COUNTRY CLUB HEIGHTS EROSION CONTROL PROJECT

Feasibility Report

With December 2016 Erratum

Errata Sheet for the Country Club Heights Erosion Control Project Feasibility Report CIP 95191.

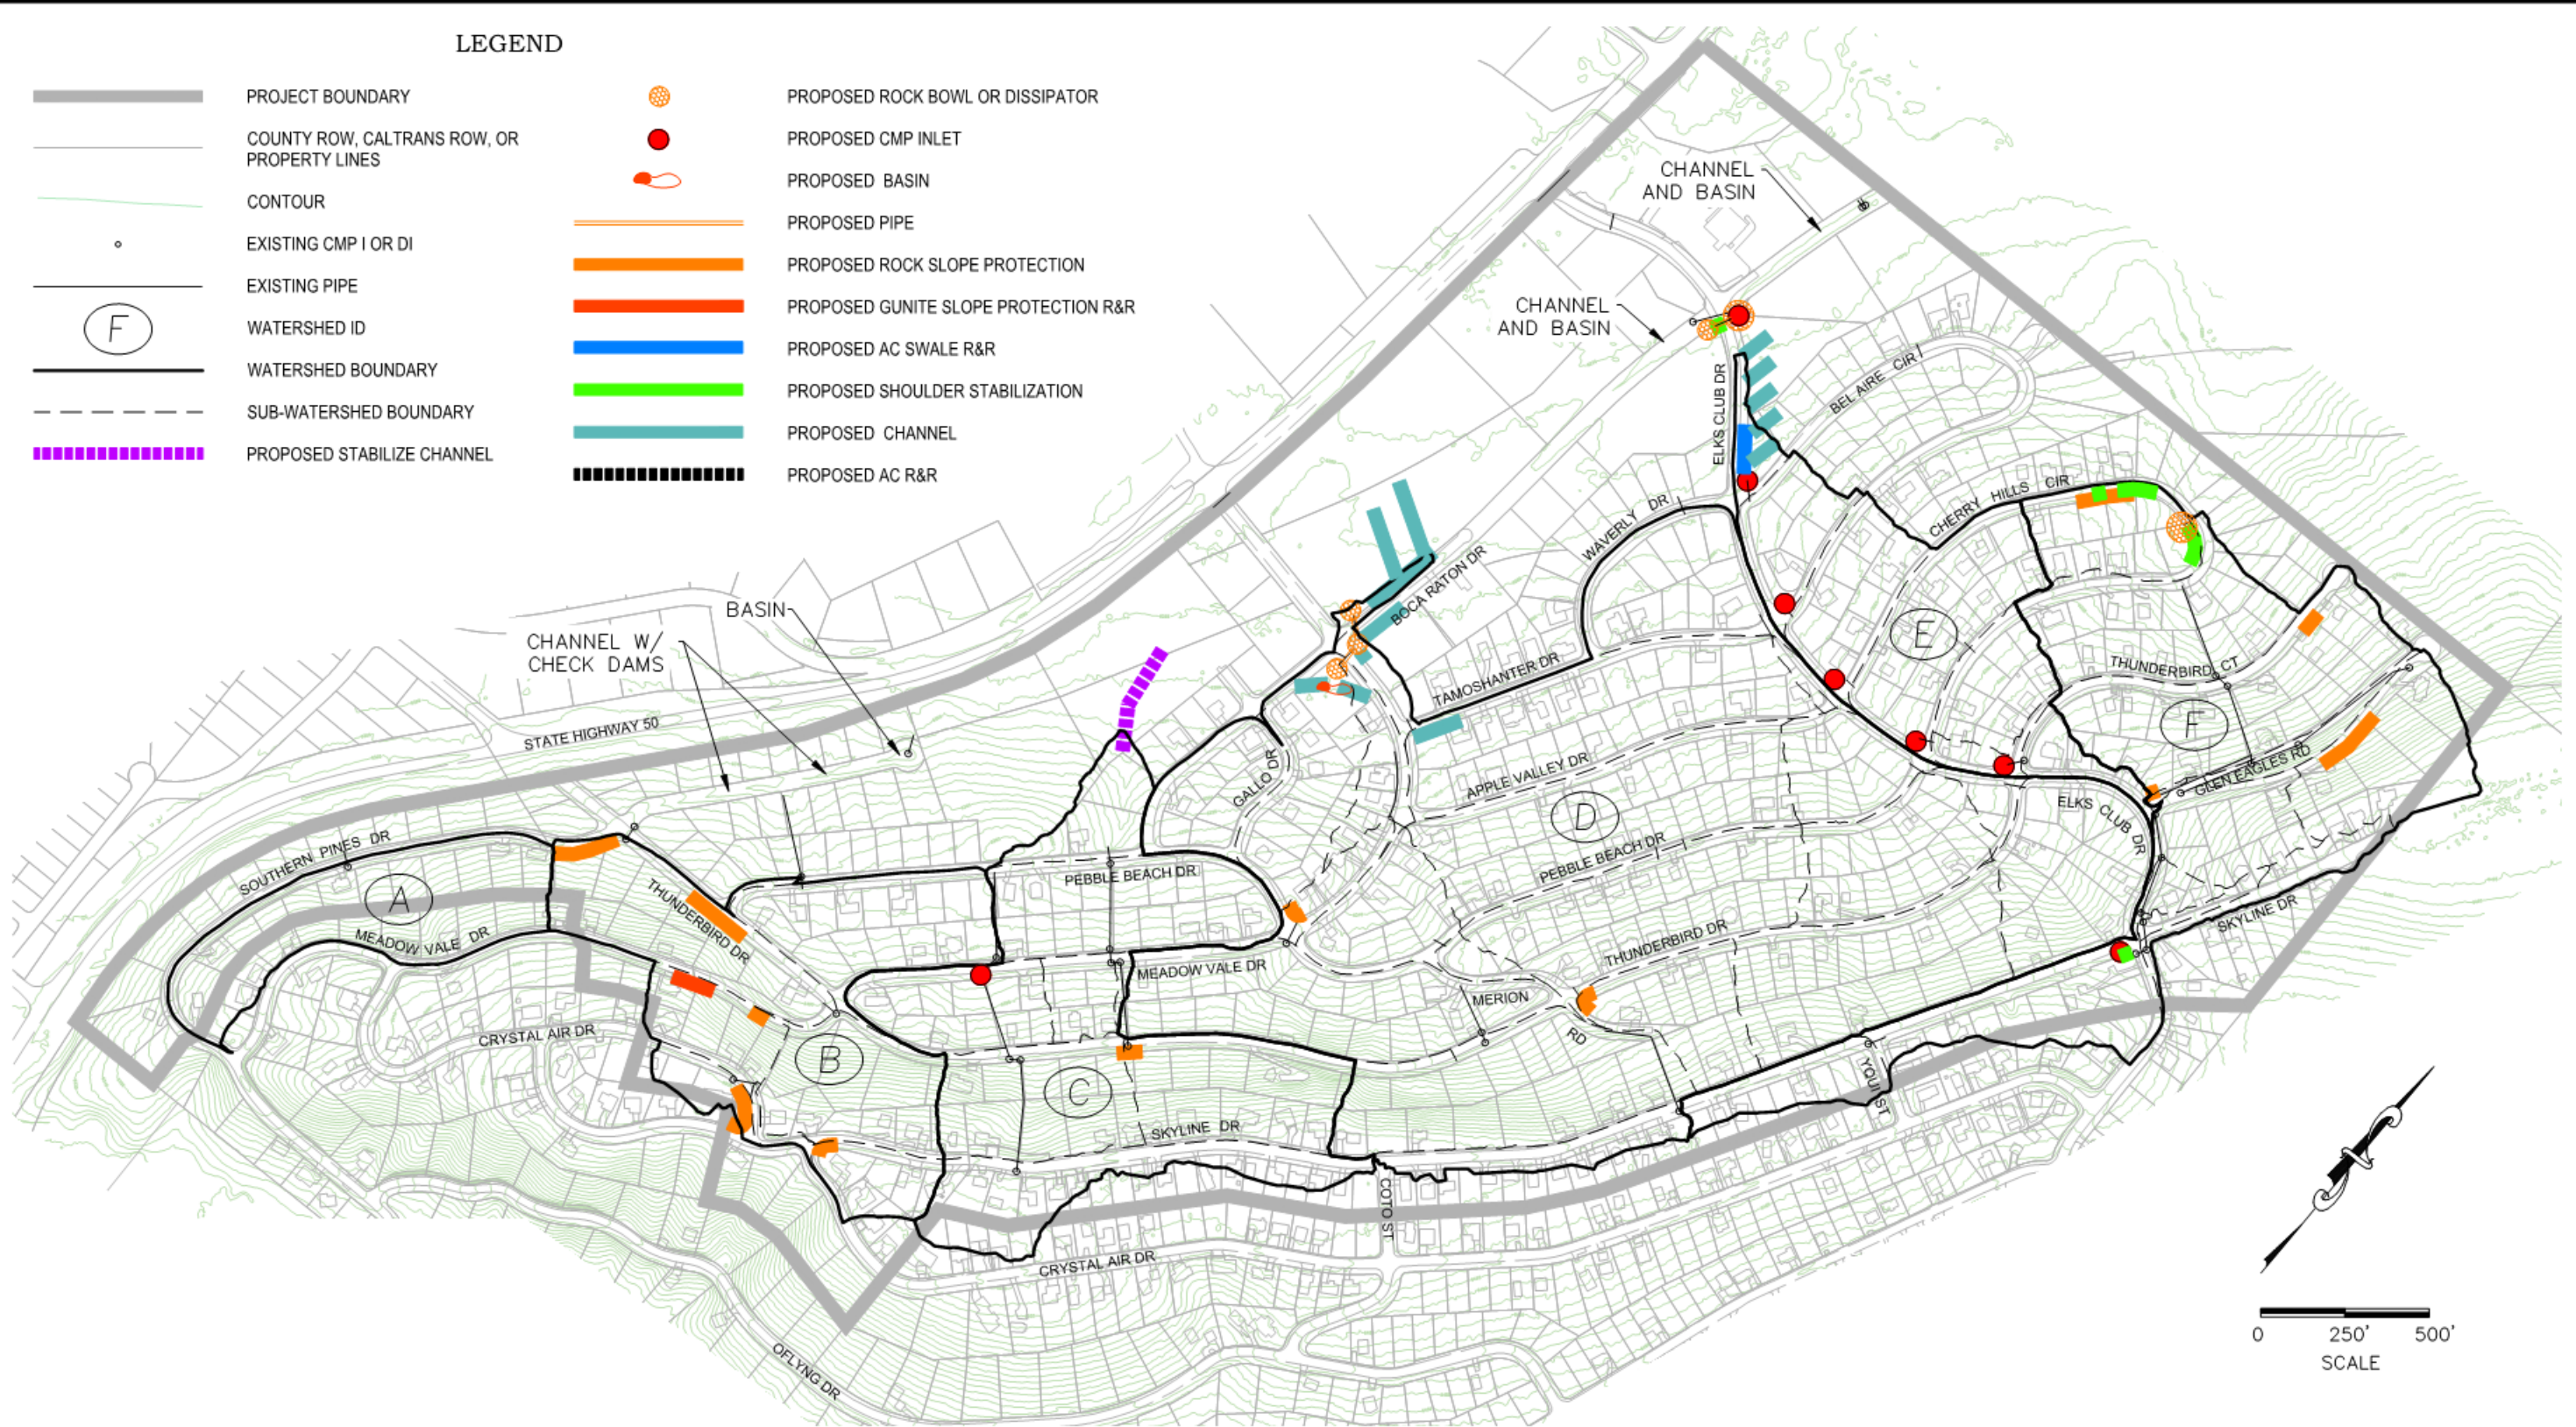
- The updates made will result in a net zero in terms of additional improvements
- Figure 19 (page 46) – updated to reflect the following changes:
 - Shorted new channels into the meadow system off of Boca Raton Drive to reflect that constructed improvements will be on parcel 033-22-305 and not on parcel 033-22-304.

- Added channel to Tamoshanter Drive (at Meadowvale Drive)
 - Relocated proposed CSP Inlets from Cherry Hills Circle to Skyline Drive at Elks Club Drive
